HUGHES ENVIRONMENTAL CONSULTING

April 16, 2021

I am writing on behalf of the Port Place Development to request approval for a number of minor revisions to the overall plans that were approved under DEP file number 051-0973. Attached you will find plans and supporting information for these changes, which include:

PORT PLACE
by Evergreen Commons, LLC
Newburyport, MA

SITE PLAN DRAINAGE UPDATE
 S.SAWYER/DCI
 MARCH 31, 2021

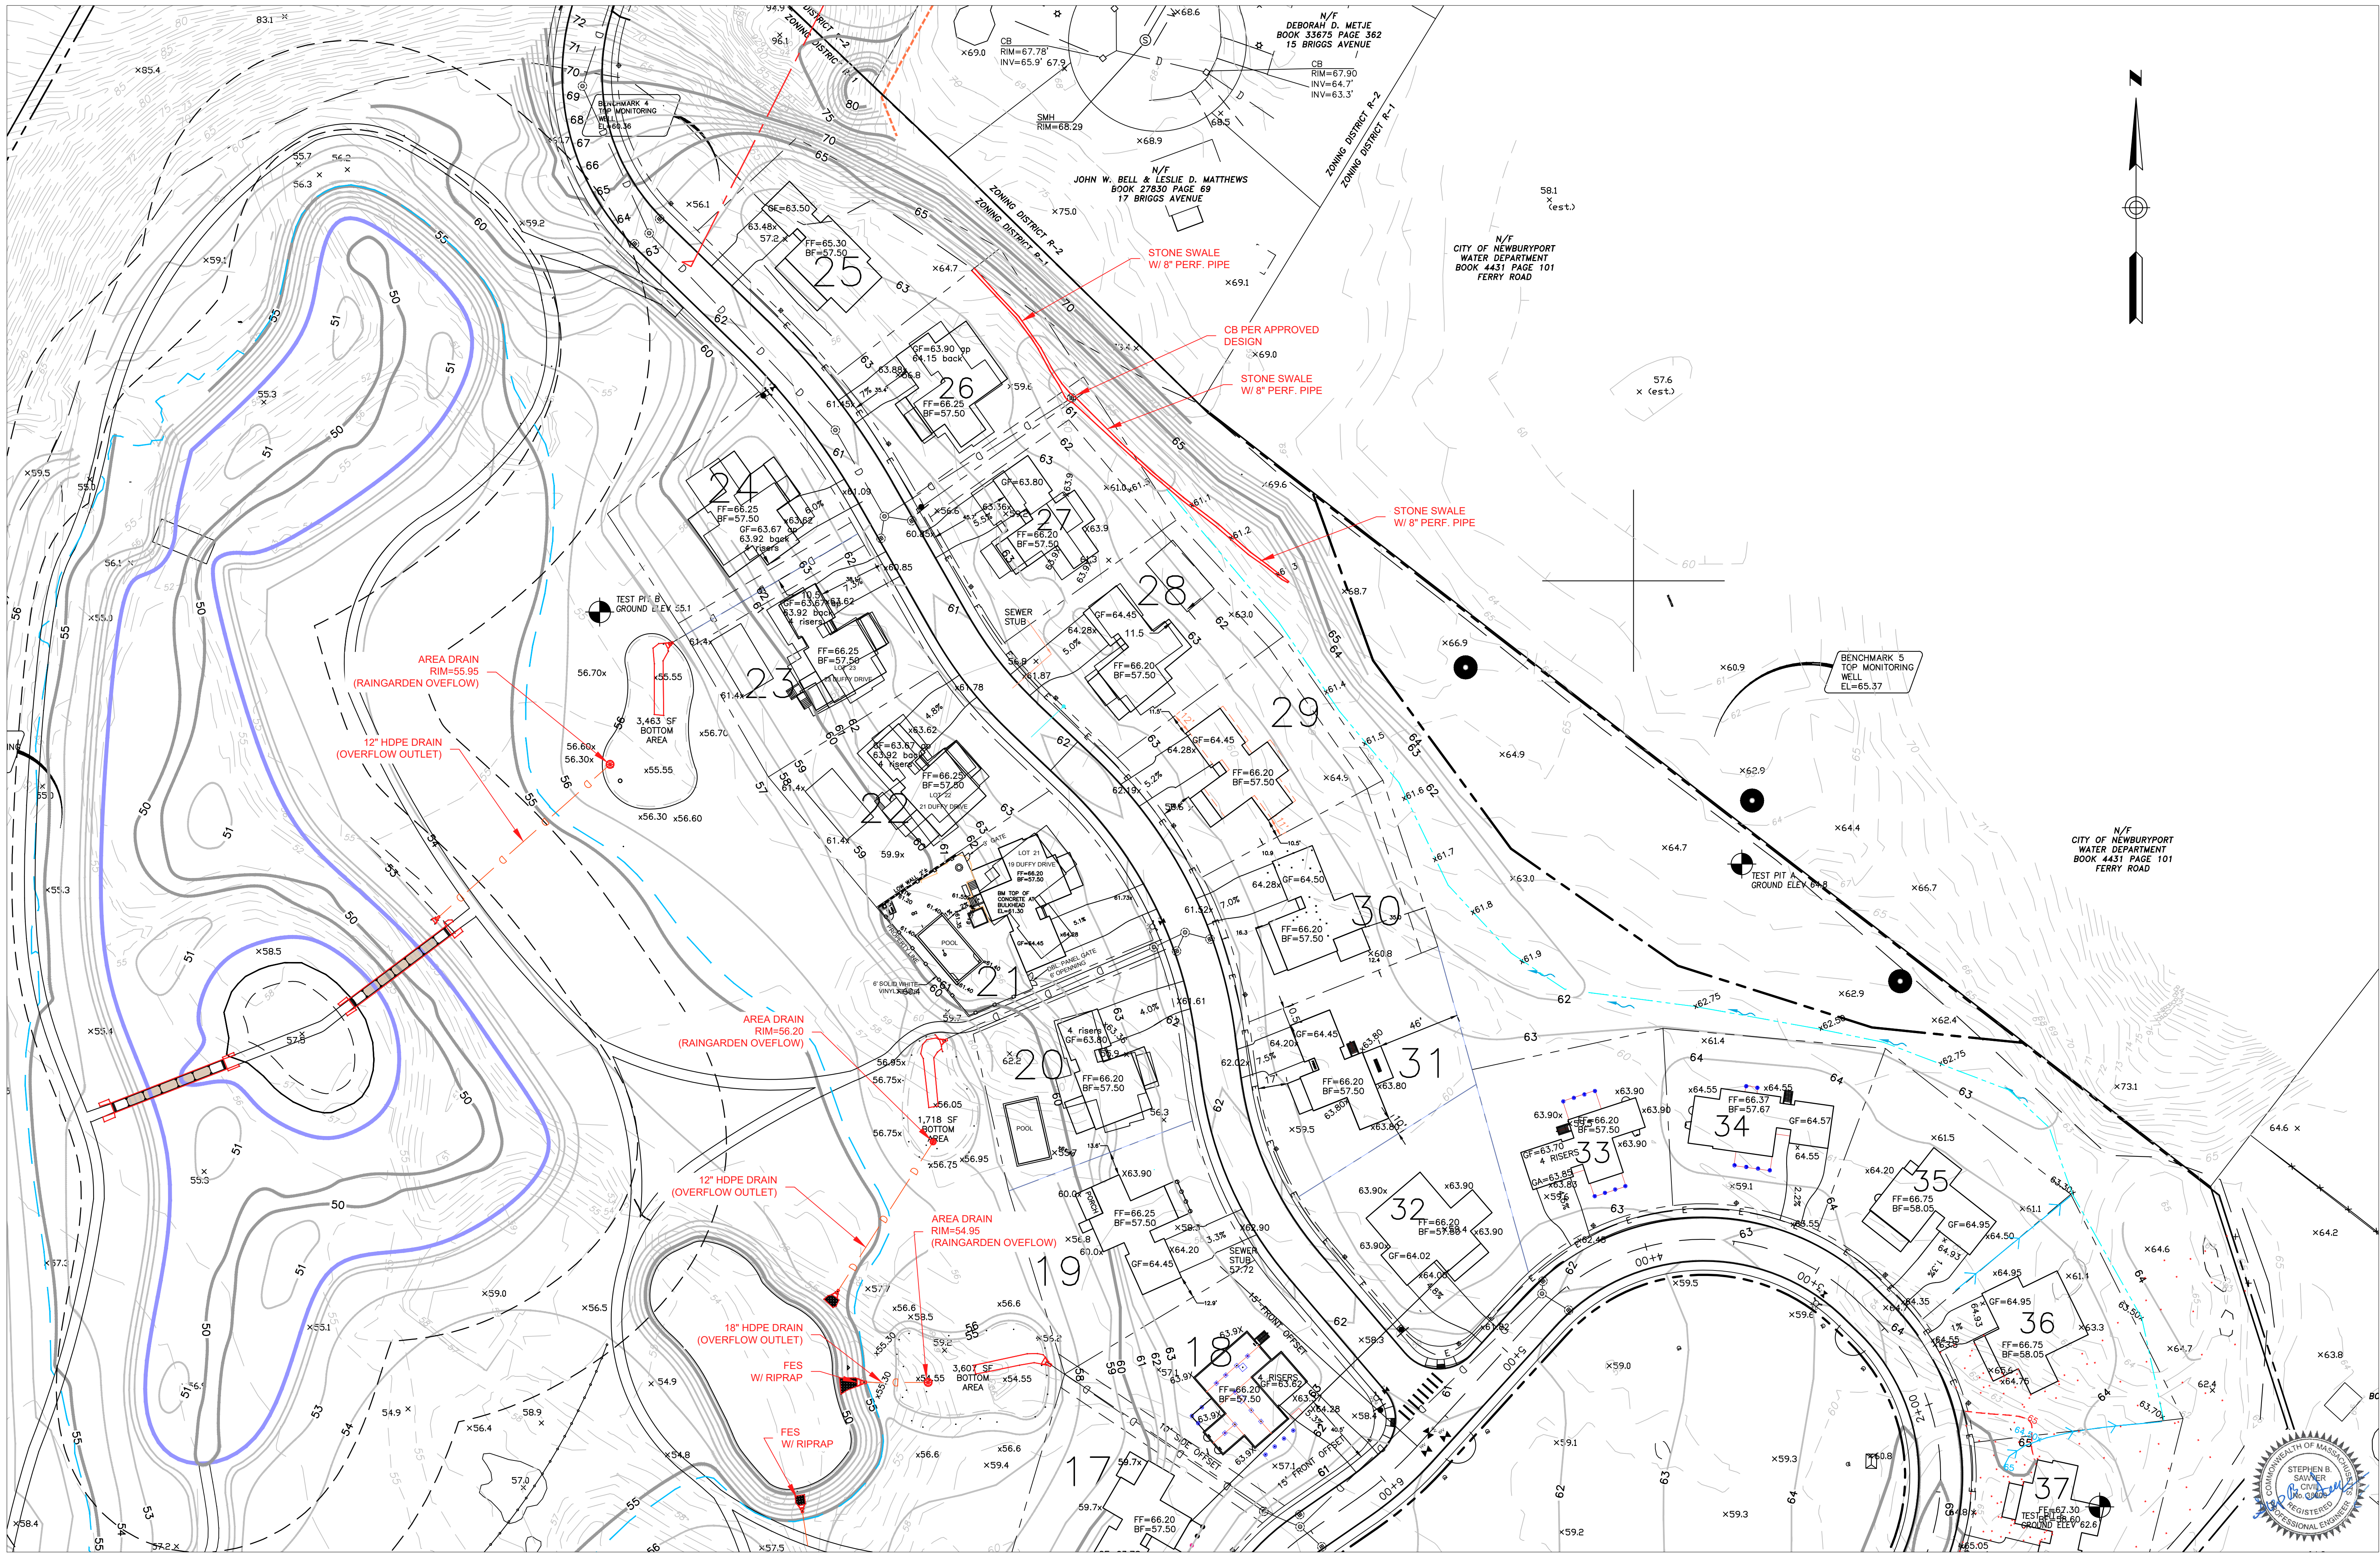
4. Stormwater system changes made in coordination with the City Engineer, including:
 - a. The 3 drywells and drain located behind lots 26 - 31 have been removed. We have provided a stone swale and perforated pipe to direct runoff to the catch basin located behind lots 26/27. This catch basin was included in the approved design with a the 8" pipe directing flow to Rain Garden F (this change was made at the direction of the City Engineer , Jon-Eric White.)

- b. We have provided piped overflow from Rain Gardens C, D, E & F. This was done due to erosion issues from surface overflow running overland. These changes did not change the designed water quality volume with the overflow rims set a minimum of 9 inches above the bottom of the rain gardens as in the approved design. These outlet changes were reviewed and approved by City Engineer Jon-Eric White.
- c. A drywell with outlet pipe was installed behind lot 5 along with two area drains behind lots 6-7. This was done due to flat area where some puddles remained after rain events. This did not change any of the stormwater design intent with the drainage from this area directed to rain garden B in the original design and through the provided area drain and piping with this change.

NOTE MAINTAIN TRANSITIONAL MEADOW AREA AT SAME TIME AS POLLINATOR MEADOW. NOTE IN ALL AREAS MOW AROUND SHRUBS AND TREES. REVISED 4-16-21
